OAKRIDGE DRIVE TRACT
LL 212, 20th DIST
COBB COUNTY
GEORGIA

REZONING PLAN

PETITION NO: Z-22

PLANNING COMMENTS:

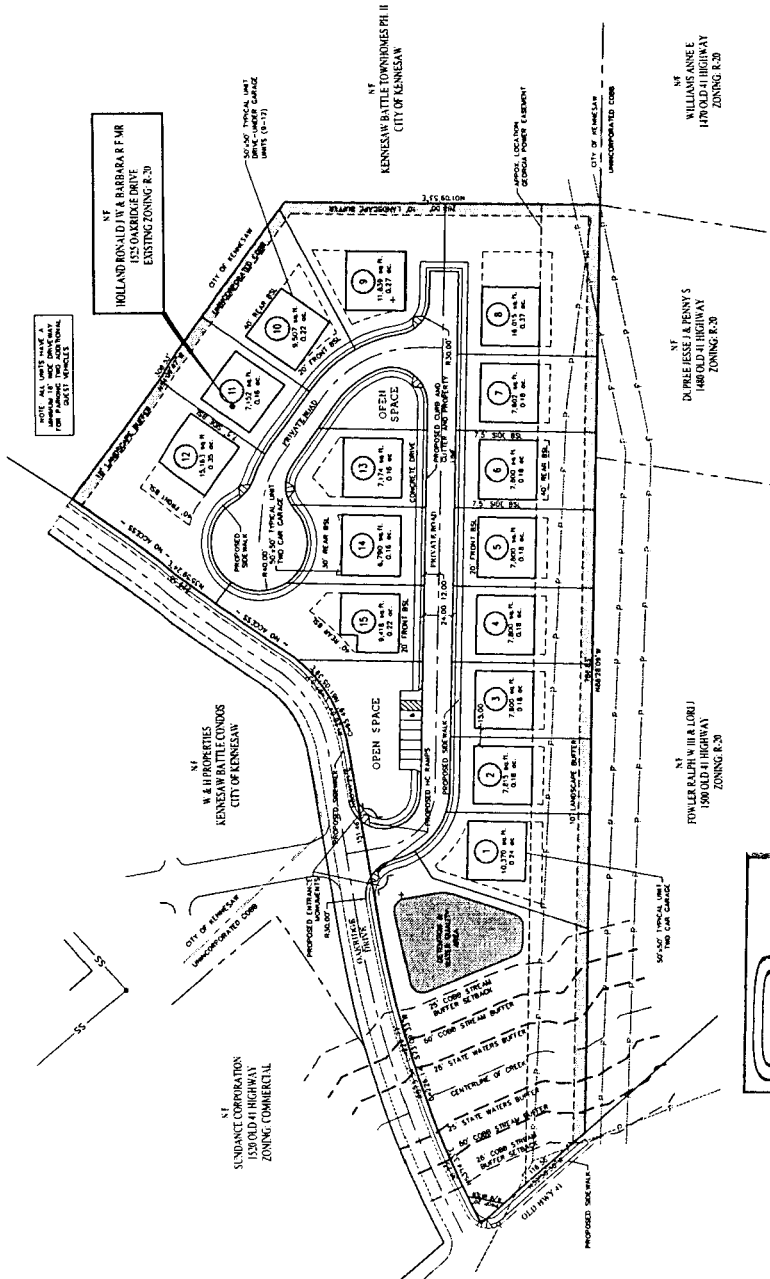
Revised Comments based on Plan received 2/15/2007

1. The extensive existing tree stand and undergrowth provide significant air/water quality, soil stabilization and storm flow mitigation benefits for this watershed. Construction of this project will eliminate the vast majority of this vegetation and increase pavement, storm runoff and non-point source pollution. To compensate, the First Flush Water Quality Best Management Practice Requirements must be elevated to the 1.5-inch rainfall event and each larger storm discharge controlled not to exceed the allowable discharge of the next lower, more frequent storm event (ie. 5-year storm event released at 2-year rate; 10-year event at 5-year rate; etc. to 100-year event at 50-year rate).

2. The maximum allowable impervious coverage for RA-5 lots is 40%. The revised plan eliminates the rear-loading of lots 1-7, which brings the proposed development under the impervious limit. However, the new road layout is less efficient and locates a large cul-de-sac on the steepest portion of the site. The original hammerhead layout is preferred and would require less grading.

3. Lots 12 - 15 will naturally drain to Oakridge Drive. Curb inlets will likely be required along the southern side of Oakridge Drive to accommodate this additional runoff and direct it to the proposed detention pond.
